Y-810-XX21000-0*115

TITLE: 2.54mm Crimp Type IDC Housing

DWG NO.: Y-810-3021000-08115

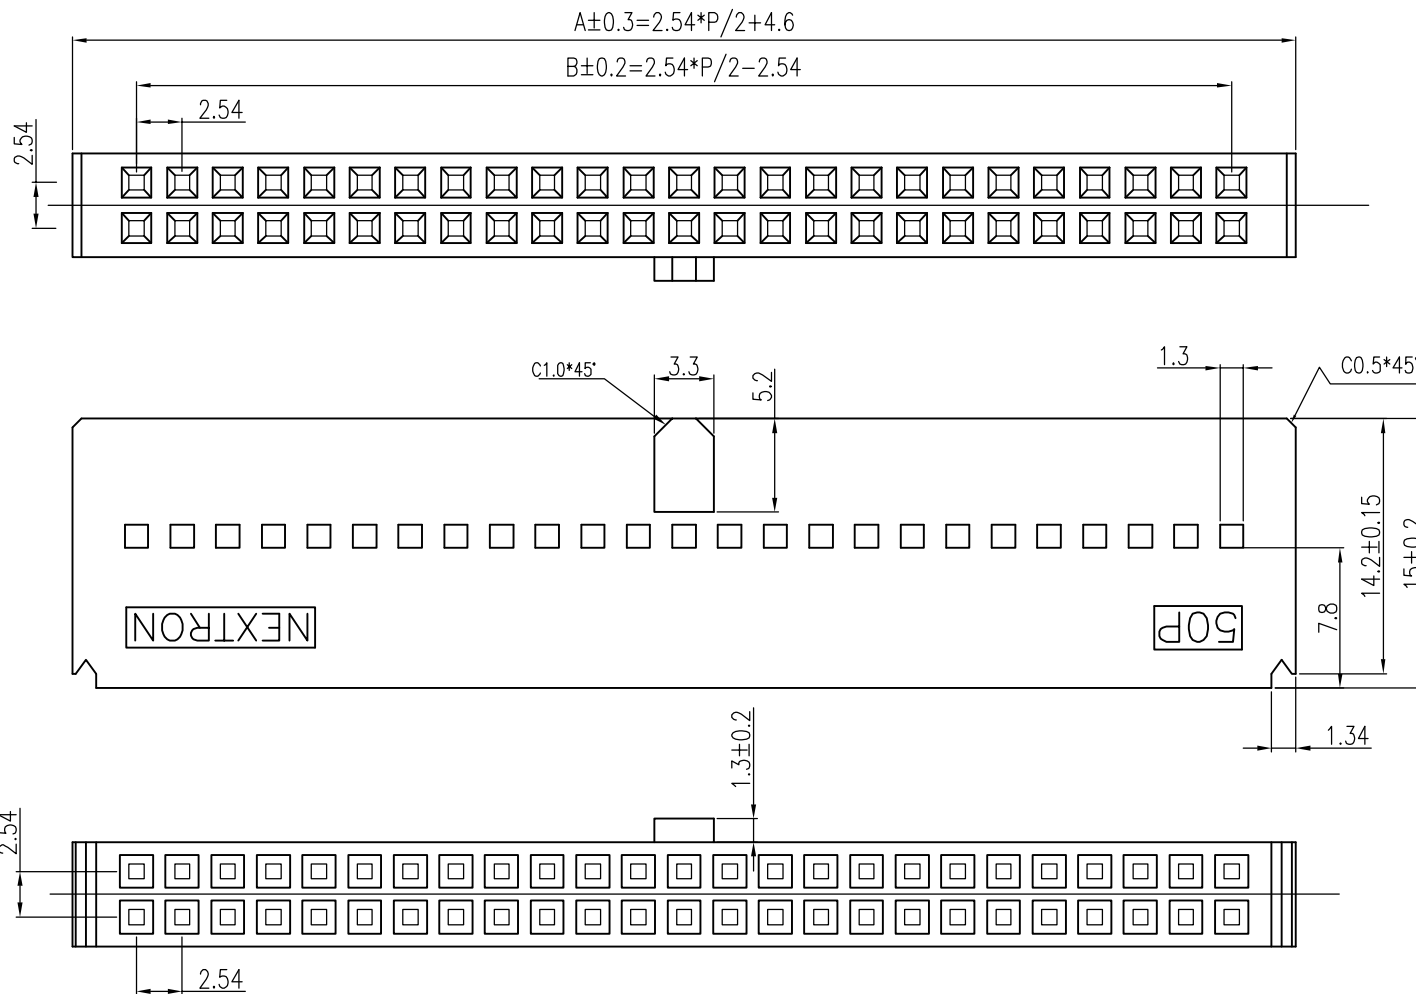
REV.	ECN NO.	APPD	DATE
A0	RELEASE	cheng	05/24'10
A1	侧钩孔尺寸加大到1.3	niezhengqi	06/23'14
